[Docket No. 96-NM-75-AD; Amendment 39-9581; AD 96-09-07]

Airworthiness Directives; Boeing Model 757 Series Airplanes Equipped with Moog Spoiler Actuators

ACTION: Final rule; request for comments.

APPENDIX 1

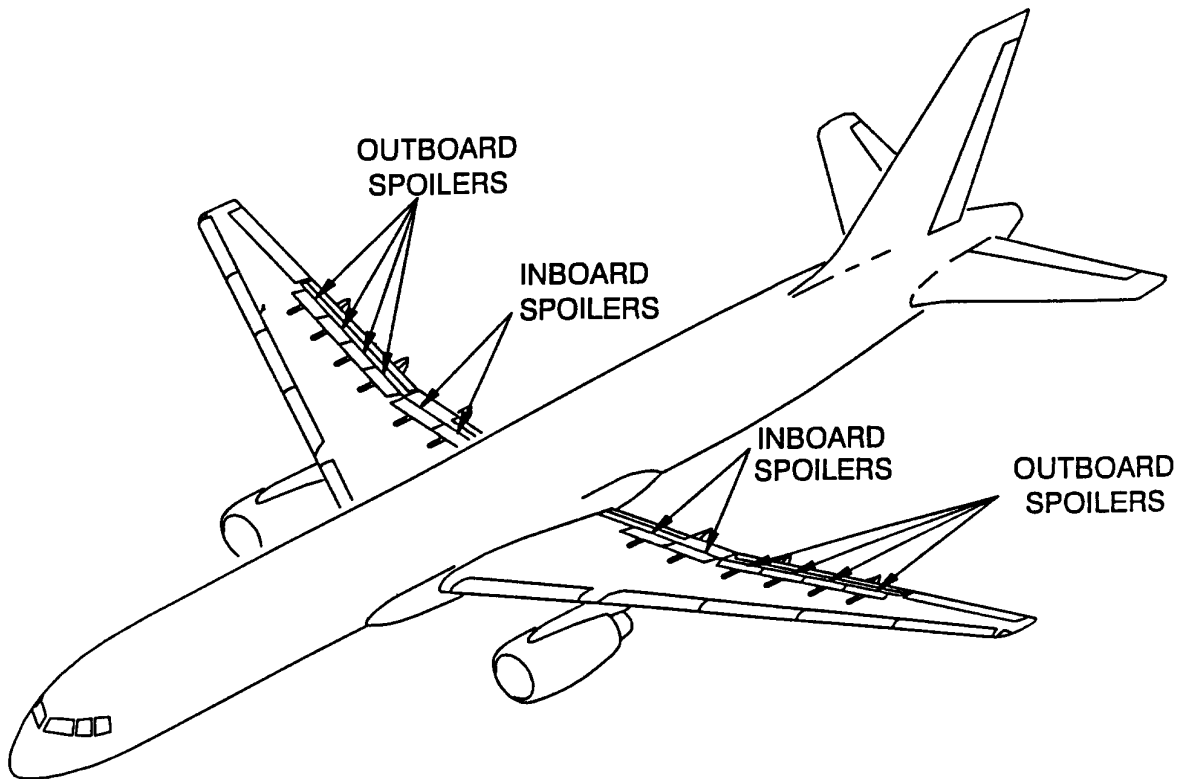
(1) While the airplane is on the ground, extend the flaps to 40 degrees and visually inspect the spoiler actuator EHSV assembly to determine the location of the second stage bias spring end cap assembly.

(2) If the second stage bias spring cap assembly is on the aft or lower side of the EHSV assembly, prior to further flight, replace the EHSV, having Abex part number 72196, with a serviceable unit in accordance with the airplane maintenance manual.

NOTE 2: To be correctly positioned, the second stage bias spring cap assembly should be on the upper or forward side of the EHSV assembly. Appendix 1 of this AD provides a visual representation of the correct positioning of the EHSV assembly.

SECOND STAGE SPRING END
CAP PROTRUSION SHOULD
NOT EXTEND ON THIS SIDE
(UNDERSIDE) OF THE EHSV
